DOCKETED			
Docket Number:	23-OPT-02		
Project Title:	Darden Clean Energy Project		
TN #:	261851-7		
Document Title:	Staff Memorandum on Record of Proceedings_Attachment 6		
Description:	N/A		
Filer:	Ngoc Tran		
Organization:	California Energy Commission		
Submitter Role:	Commission Staff		
Submission Date:	2/18/2025 2:20:37 PM		
Docketed Date:	2/18/2025

While evaluating the application with respect to removal of the green hydrogen component, Water staff determined that the applicant's Data Request Response Set 4 (TN 256296) did not fully respond to Data Request DR WATER-19.

## Figure 4 DR WATER-19 Preliminary Drainage Map with Detention Basins

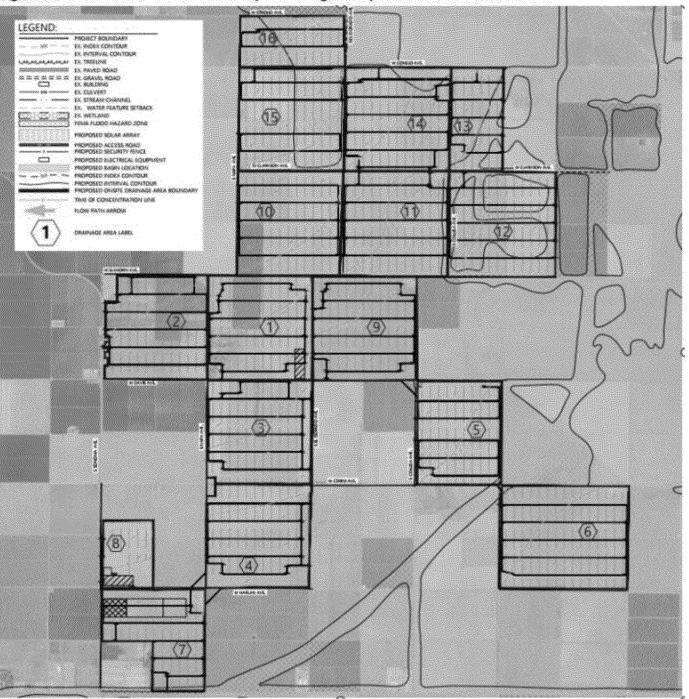
Here's a map of the 16 detention ponds. Let me know if you have any questions, and where you are at with review of my draft Avian Solar Conservation Plan. Thanks!

Something I need to mention. There will be 16 detention ponds with standing water at a frequency that is yet to be determined. But the surface area of the 16 ponds averages 4.63 acres. So not only will there be the attractant of the panels' polarization, but there could be actual standing water across the site. As I mentioned, the applicant has yet to provide data on how often that is projected to occur, or the time to percolate.

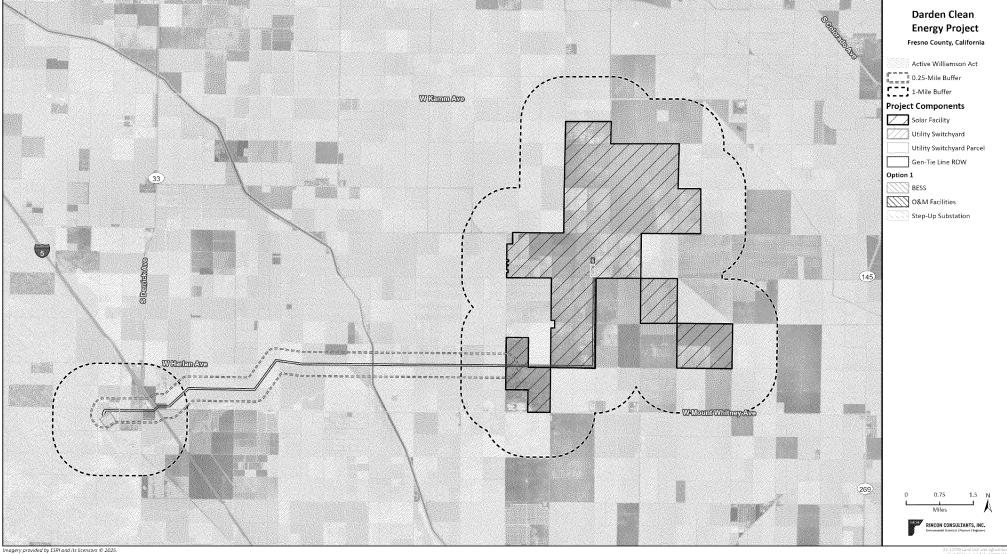
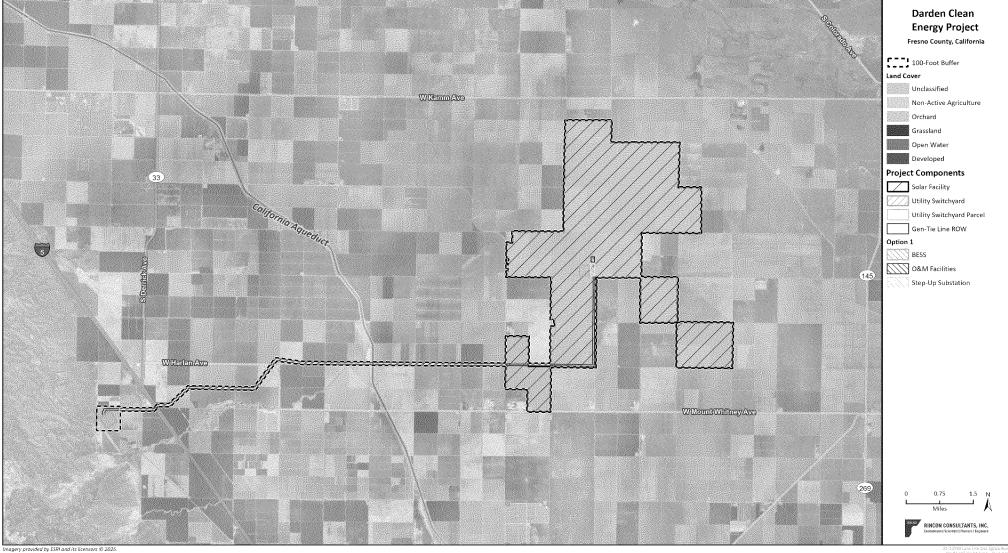
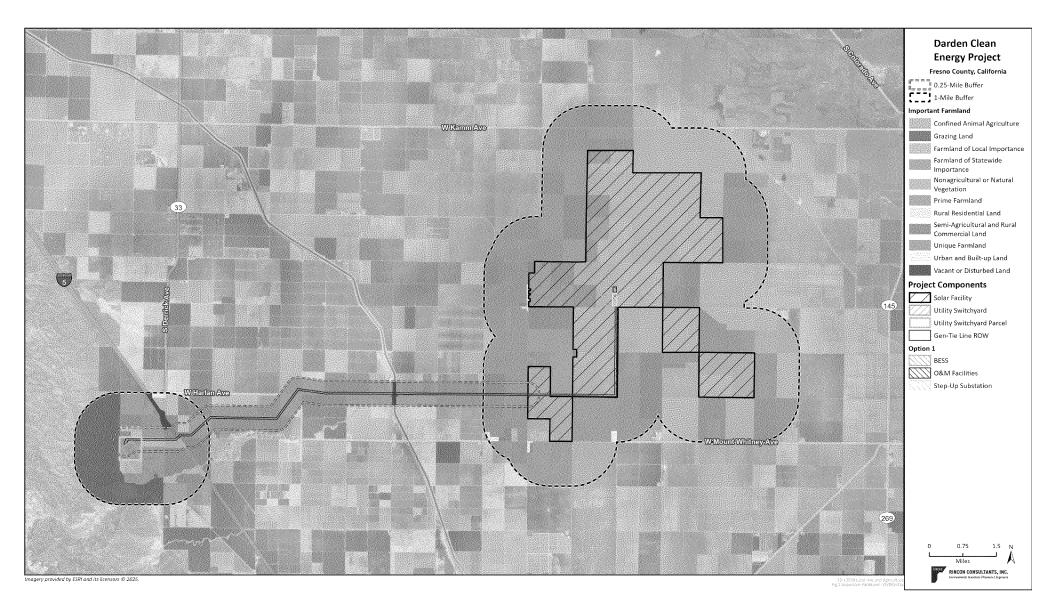
Figure 5.2-5a Overview of Agricultural Uses Within the Study Area on Pg. 5.2.25 (Land Use TN253034) Figure 5.2-6a Overview of Farmland Mapping and Monitoring Program Designations on Pg. 5.2-34 (Land Use TN253034) Figure 5.2-7a Overview of Existing Williamson Act Contracts Within the Study Area on Pg. 5.3-43 (Land Use TN253034)
